FIELD SERVICE CAMPAIGN – 21105

Exhaust Gas Recirculation Valve (EGRV) Mounting Bolts

International® LT®, HV™ and RH™ Series trucks with International® A26 engine only.

Figure 2. Correct EGRV Mounting Bolts

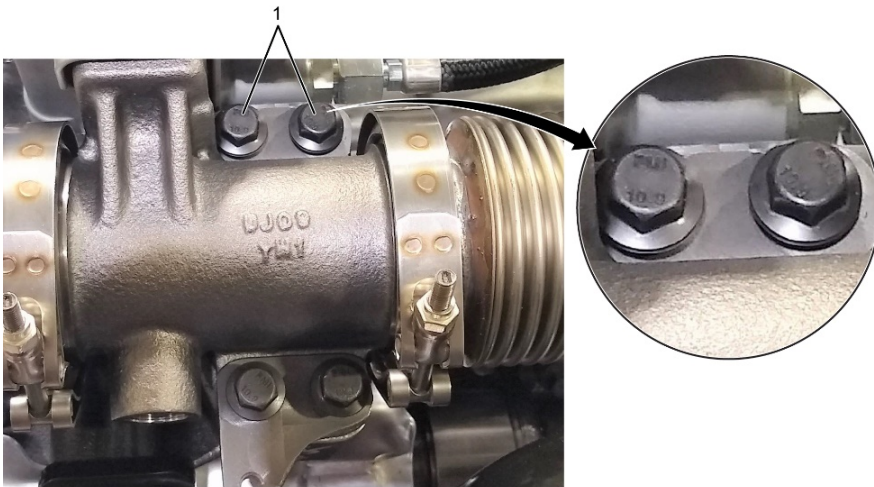
1. Incorrect bolt (shiny with smooth head) (4)
-
9. Inspect EGRV mounting bolts for incorrect bolts.
 - a. If bolts (Figure 2, Item 1) are dull with recessed head, no action is required. Proceed to Step 13.
 - b. If bolts (Figure 3, Item 1) are shiny with smooth head, continue to Step 10.

10. Using a crisscross pattern, remove two of the incorrect mounting bolts (Figure 3, Item 1) and install two new mounting bolts (Figure 2, Item 1). Discard bolts.
11. Using a crisscross pattern, remove two remaining incorrect mounting bolts (Figure 3, Item 1) and install two new mounting bolts (Figure 2, Item 1). Discard bolts.
12. Torque mounting bolts to 34 lb-ft (46 N·m) in a crisscross pattern.

1. Correct bolt (dull with recessed head) (4)
